OD Hydrology

18 July 2022

Re: Review of surface water aspects of Mount Pleasant Optimisation Project

Figure 1: Tailings storage location

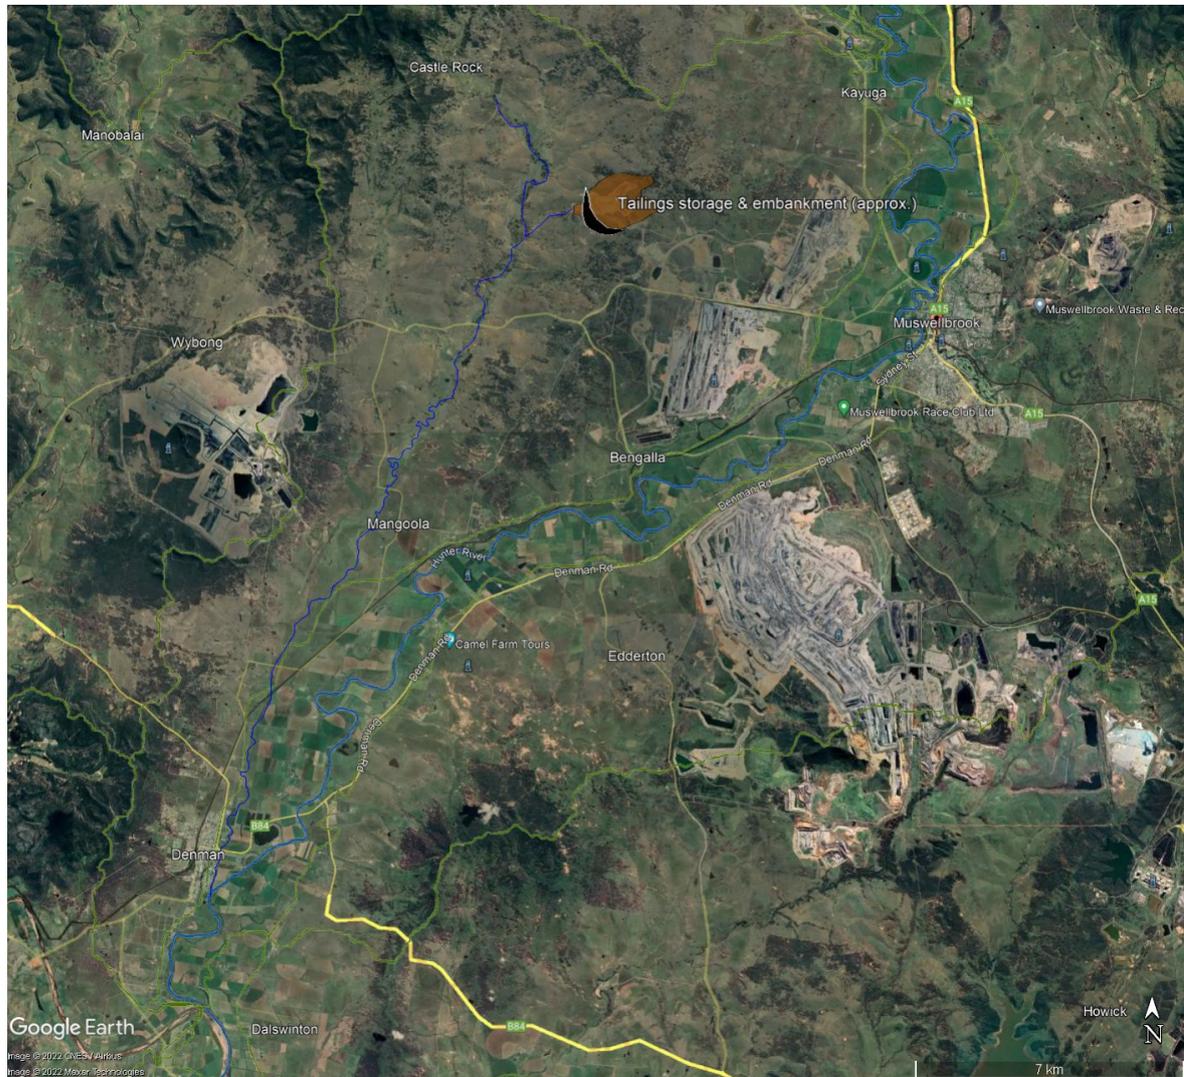
The proposed fine coal rejects (or tailings) management and post-mining concept proposed comprises a significantly modified approach than previously proposed and approved in 1999. The original 1997 EIS proposal was based on a series of terraced progressively filled and rehabilitated storage cells. The new proposed approach consists of a single, large, continuously filled storage and increasing dam

embankment, intended to store approximately 36M cubic metres. The final dam wall embankment is proposed to be approximately 60m in height, an increase of approximately 39m from previous planning, with the entire volume of tailings located in the upper portion of the Sandy Creek catchment, which drains ultimately through the highly productive alluvial area to the south and ultimately to the Hunter River (Figure 1).

With the location of the storage directly upstream of highly productive agricultural land, Hunter alluvial aquifer and Hunter River itself, any potential for embankment failure and discharge of tailings represents a major environmental, social and economic issue.

In his presentation to the IPC, Dr Steven Pells raised his concerns regarding tailings dam failures over history, with the proposed storage representing "... a very significant structure" and "... a big risk item". Dr Pells concerns were mostly directed towards embankment design and the potential for embankment saturation through operational and mine sequence changes over time, which itself represent a key risk over both the life of the Project and beyond.
